**Centre for Marine Science and Technology, Curtin University, Assessment of:**

- A. Predicted underwater sound impacts on marine mammals in sand mining area and recommendations**
- B. Review of modelling of underwater noise from the proposed Trans-Tasman Resource Ltd (TTRL) iron sands extraction operation carried out by AECOM**

CMST Project 1504, Report 2017-08, Date Prepared: 18-May-2017

Fig.1. IMT 1994, Fig. 3

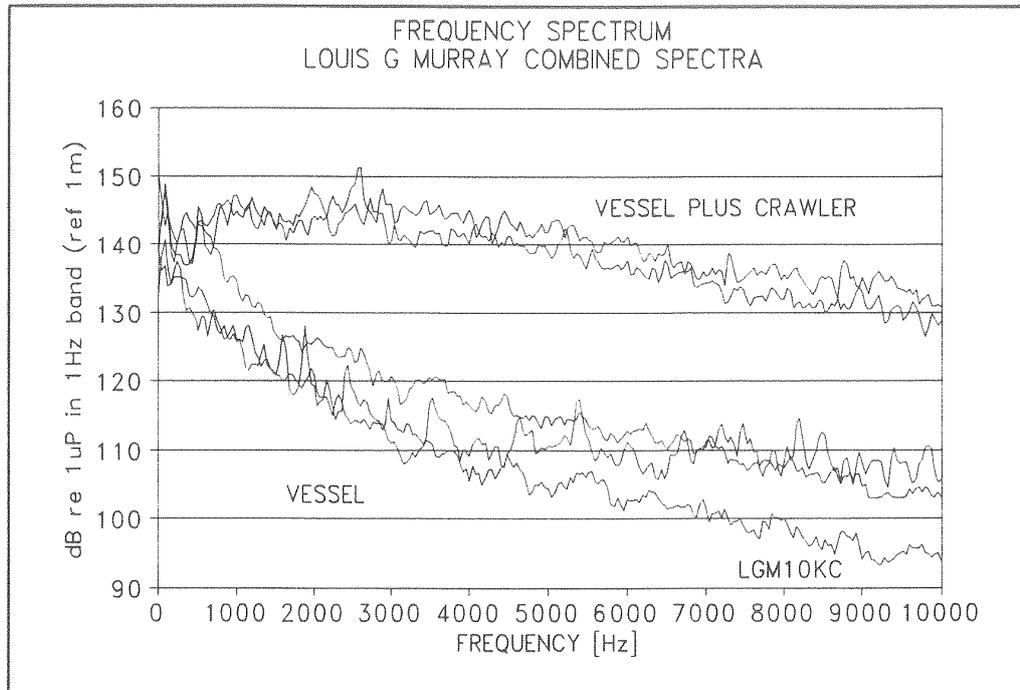
AECOM refer to two reports containing measured data from a De Beers Marine subsea mining operation using equipment similar to that proposed for the TTRL operation (see IMT 1994 and IMT 1995). The first of these reports provides the measurements of crawler noise plotted in Fig. 1 (Figure 3 in that report) from which a source level can be estimated.

Estimating the dominant part of the crawler noise spectrum as having an average source spectral level of about 145 dB re 1  $\mu$ Pa in 1 Hz bands, and a 3 dB bandwidth extending from about 500 Hz to 4500 Hz, results in a source level of:

$$SL = 145 + 10 \log 4000 = 181 \text{ dB re } 1 \mu\text{Pa @ } 1\text{m.}$$

Note that the vessel itself may be generating higher noise levels when the crawler is in operation and it is not possible to separate their individual contributions from these measurements.

Fig. 2, IMT 1994, Fig. 9

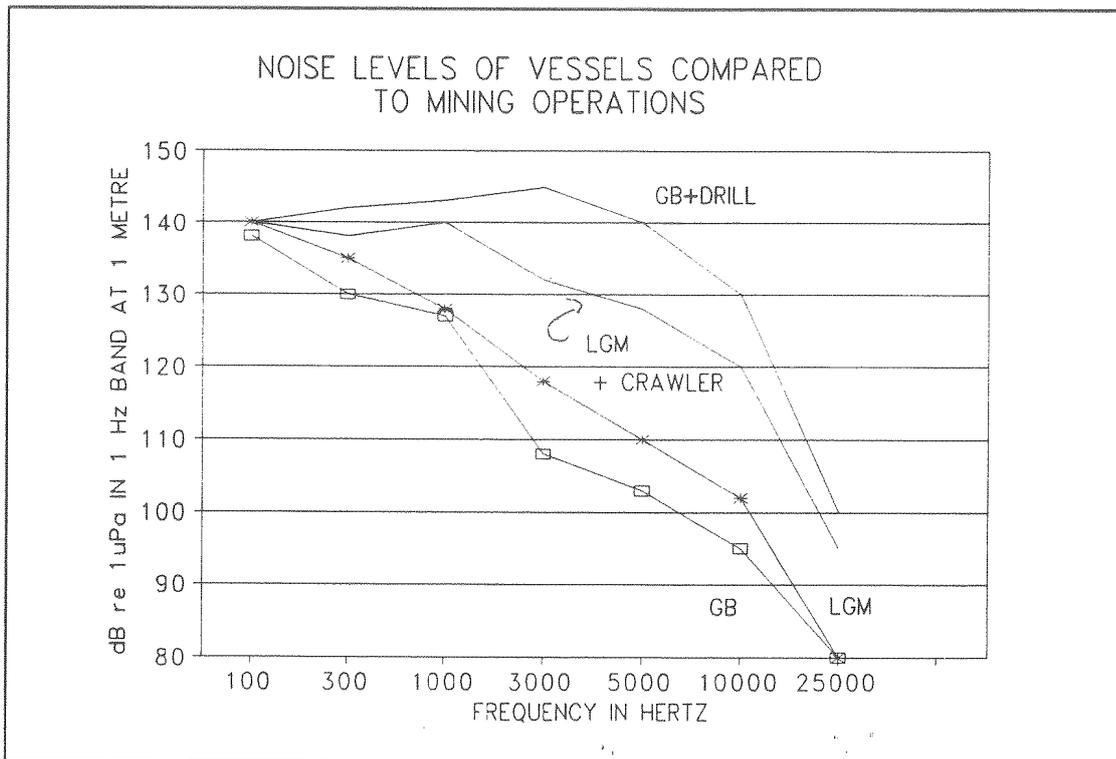
A comparison of figures 3, 4, 7, and 8 in IMT 1994 with Figure 9 in the same report (reproduced in Fig. 2 below) indicates that the labels of the GB+DRILL and LGM+CRAWLER curves in Figure 9 have been swapped. It is therefore likely that the upper curve, rather than the second highest curve, corresponds to the crawler data. This is important as this plot, with the same labels, but with some minor differences at low frequencies and a change from a linear to a logarithmic frequency axis has carried through to IMT 1995, Fig. 6, which appears as Fig. 1 in the AECOM report.

It is implied in the AECOM report that this figure is the source of the TTR crawler source spectral data given in Table 1, however the reviewer has been unable to reconcile the two. Conversion of 1 Hz spectral levels (as in the IMT report) to octave band levels (as in Table 1 of the AECOM report) requires adding a bandwidth correction equal to  $10\log(w)$  where  $w$  is the bandwidth of the octave band being converted (Hz). Reading the spectral levels by eye from AECOM Fig 1, and applying the calculated bandwidth corrections results in the gray and orange curves in Fig. 3 below, corresponding to the upper and lower curves in AECOM Fig. 1 respectively. These can be seen to bear little resemblance to the AECOM Table 1 octave band levels (yellow curve). What appears to be an error in AECOM's calculation of the octave band source spectrum for the crawler invalidates the results of the modelling that was then based on this source spectrum because, in these relatively shallow water depths, sound at frequencies between 1000 Hz and 10000 Hz, where the AECOM source spectrum appears to be up to 30 dB lower than it should be, would be expected to propagate more efficiently than sound at lower frequencies, at least out to ranges of a few tens of kilometres.

Fig. 3. A comparison between octave band source levels calculated by the reviewer based on the lower and upper curves in AECOM Fig. 1 and those given in AECOM Table 1.

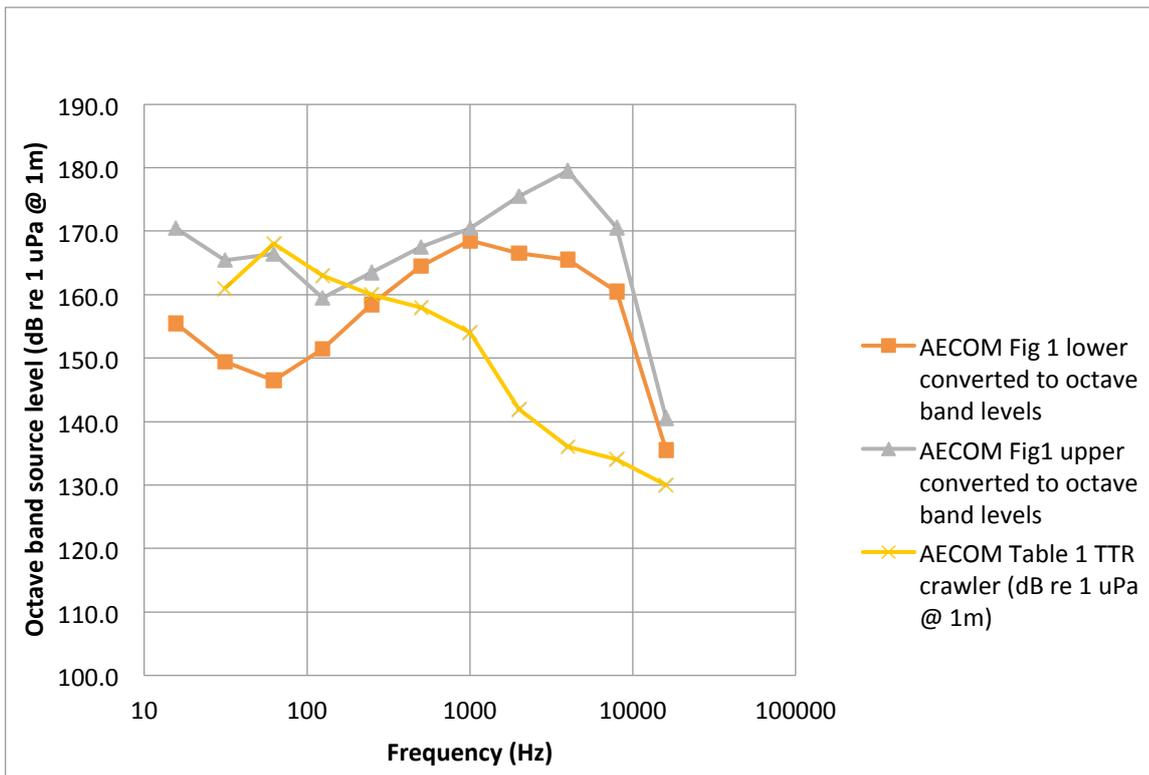
Calculating the corresponding source levels by summing the equivalent mean square pressures in each band over frequency and then converting back to dB gives the results shown in Table 1. Note that the source level of 181 dB re 1  $\mu$ Pa @ 1m estimated above using IMT 1994 Fig. 3 is within the estimation uncertainty of the result in Table 1 based on the upper curve of AECOM Fig. 1.
